Delegated Report

Householder Planning Application

Planning Application No: 20250688

Description: Demolition of rear garage and erection of a replacement garage.
Installation of a vehicle crossover.

Proposed Garage

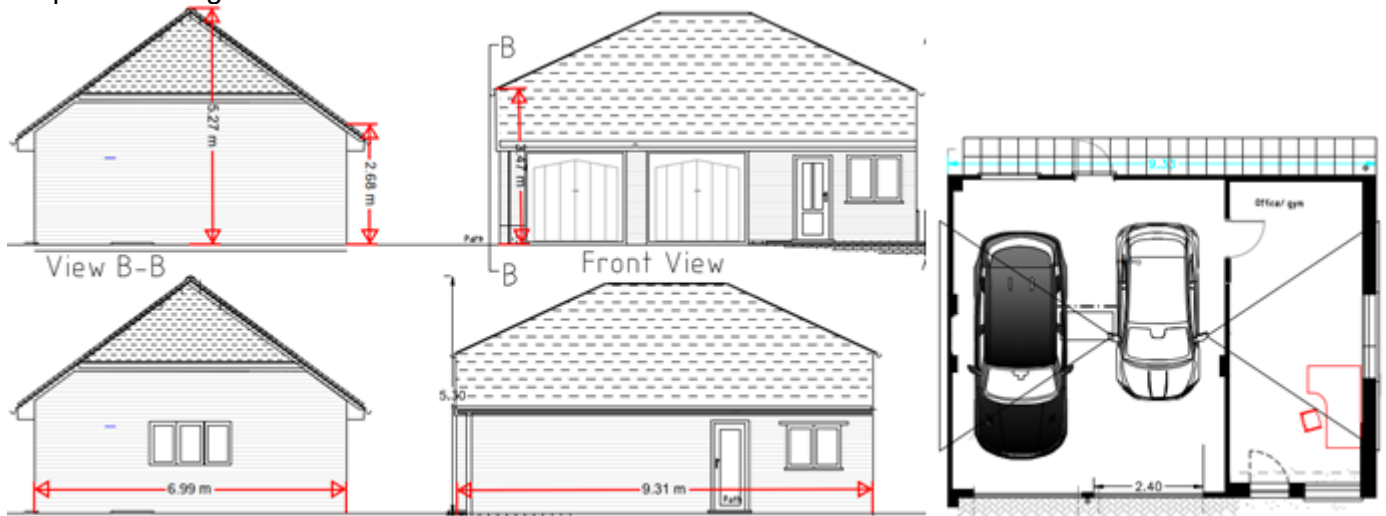
The proposed garage would measure 7m wide and 9.31m in length, with an eaves height of 2.68 and overall ridge height of 5.27m. The roof would be a barn hip with the hip having a height of 3.47m. The replacement garage would provide 2no. parking spaces and an office/gym area.

The new garage would be located in the same position as the existing and would extend further within the rear garden of the property, leaving the existing hardstanding to the east (rear) for manoeuvring.

The existing garage is located to the rear of the property and is in need of replacement as it is not fit for purpose and is significantly undersized and unsuitable for the parking of a modern sized vehicle. Whilst the proposed garage is larger than the existing, it is located within the same position and would not project further to the rear and sits within the garden area of the property. The overall height is greater than the existing, however the barn hip design reduces the bulk and massing of the roof and the garage itself is set more than 15m from The Gables to the northeast and over 20m from Te Koanga to the east. The existing hardstanding to the side (east) would remain, ensuring that ample space is provided for vehicle manoeuvres into the garage and reduces any impact on the neighbouring properties.

In terms of the replacement garage, there is no objection to the location, size and design.

Existing and Proposed Block Plans

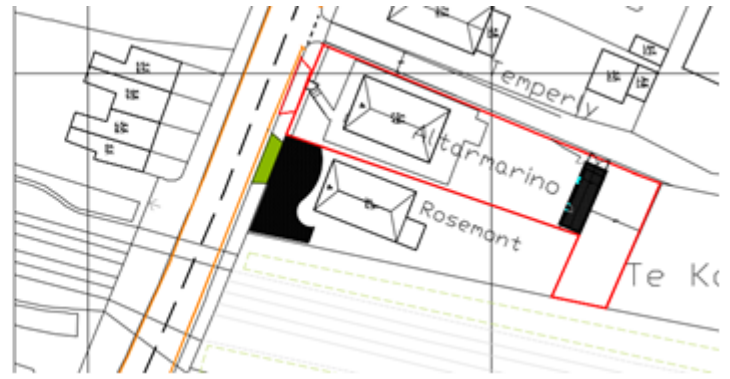
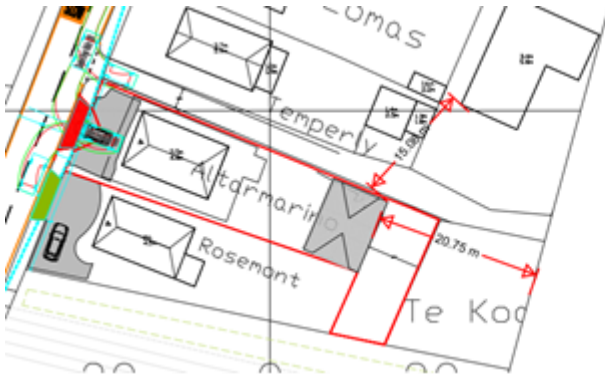
The proposed parking to the front would be a single vehicular crossover to the front and hardstanding for two vehicles. The proposal would be similar to the adjacent property Rosemont.

The proposed crossover would be similar to that of the adjacent property Rosemont, therefore the principle of the crossover and hardstanding is acceptable. The proposed block and parking plans have minimal information in terms of soft and hard landscaping. Therefore in order to address the impact of the proposal on visual amenity, a condition of hard and soft landscaping will be imposed on any forthcoming decision.

The proposed vehicular crossover would be similar to that of the adjacent property Rosemont and would provide adequate sight lines. As such KCC Highways and Transportation do not raise objections to the revised single crossover scheme, subject to conditions of the provision of visibility splays and pedestrian visibility splays which will be imposed on any forthcoming decision.

Proposed Crossover

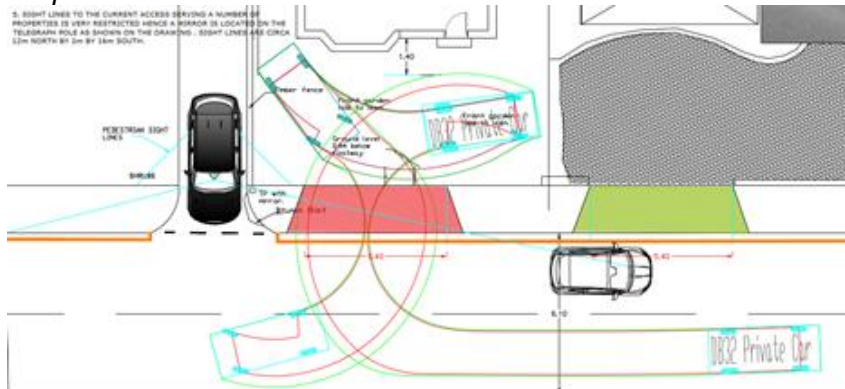
The proposal is for a single crossover and parking area to the front of the property. The area at the front of the property is currently laid to lawn.
